APPLICATION NO.	FILING DATE	FIRST NAMED INVENTOR	ATTORNEY DOCKET NO.	CONFIRMATION NO.
10/736,618	12/17/2003	Yoshihiro Ohkura	X2007.0147	4069
32172	32172 7590 06/28/2005		EXAMINER	
DICKSTEIN SHAPIRO MORIN & OSHINSKY LLP 1177 AVENUE OF THE AMERICAS (6TH AVENUE)			NGUYEN, DILINH P	
41 ST FL.	E OF THE AMERICAS (61	ART UNIT	PAPER NUMBER	
NEW YORK, NY 10036-2714			2814	
			DATE MAILED: 06/28/2005

Application No.	Applicant(s)				
Office Action Summary		10/736,618	OHKURA, YOSHIHIRO				
		Examiner	Art Unit				
		DiLinh Nguyen	2814				
The MAILING DATE of this communication appears on the cover sheet with the correspondence address / Period for Reply							
THE - Exter after - If the - If NC - Failu Any I	ORTENED STATUTORY PERIOD FOR REPLY MAILING DATE OF THIS COMMUNICATION. In the may be available under the provisions of 37 CFR 1.13 SIX (6) MONTHS from the mailing date of this communication. In period for reply specified above is less than thirty (30) days, a reply period for reply is specified above, the maximum statutory period were to reply within the set or extended period for reply will, by statute, reply received by the Office later than three months after the mailing end patent term

Fig.1

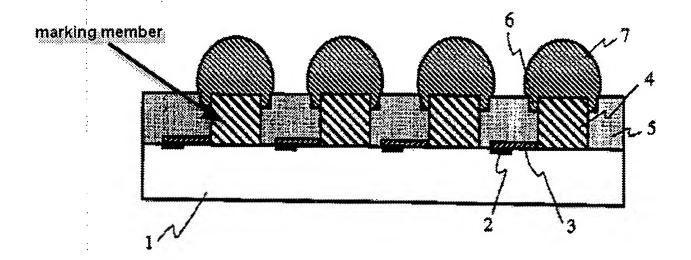
at least one marking member that is arranged in the package housing so as to realize a directivity when viewed in a thickness direction of the semiconductor chip (fig. 1, column 2, lines 56 et seq.).

Regarding claim 2, Ohuchi et al. disclose that an outline shape of the marking member includes at least one linear portion (fig. 1).

- 4. Claims 3-9 are rejected under 35 U.S.C. 103(a) as being unpatentable over Ohuchi et al. (U.S. Pat. 6495916) in view of AAPA (fig. 6).
 - Regarding claim 3, Ohuchi et al. disclose that the marking member corresponds to a copper post (fig. 1, column 3, line 1) but do not explicitly disclose the marking member is arranged independently of the plurality of conductors.

However, AAPA discloses that the marking member 520 is arranged independently of the plurality of conductors (fig. 6). Therefore, it would have been obvious to one having ordinary skill in the art to modify the device of Ohuchi et al. by having the marking member is arranged independently of the plurality of conductors, as taught by AAPA (fig. 6), in order to provide an index solder ball for use for the chip direction (page 2, lines 21-22).
 - Regarding claim 4, Ohuchi et al. disclose that the copper post serving as the marking member has a square shape (fig. 1).
 - Regarding claim 5, Ohuchi et al. disclose that the copper post is covered with a solder layer 7 (fig. 1, column 3, line 35).
 - Regarding claim 6, Ohuchi et al. disclose that the marking member has a square shape (fig. 1).

Regarding claims 7-9, Ohuchi et al. disclose that the marking member corresponds to a copper post (column 3, line 1) and it would have been obvious to increase in size compared with each of the plurality of conductors 4 (fig. 1).
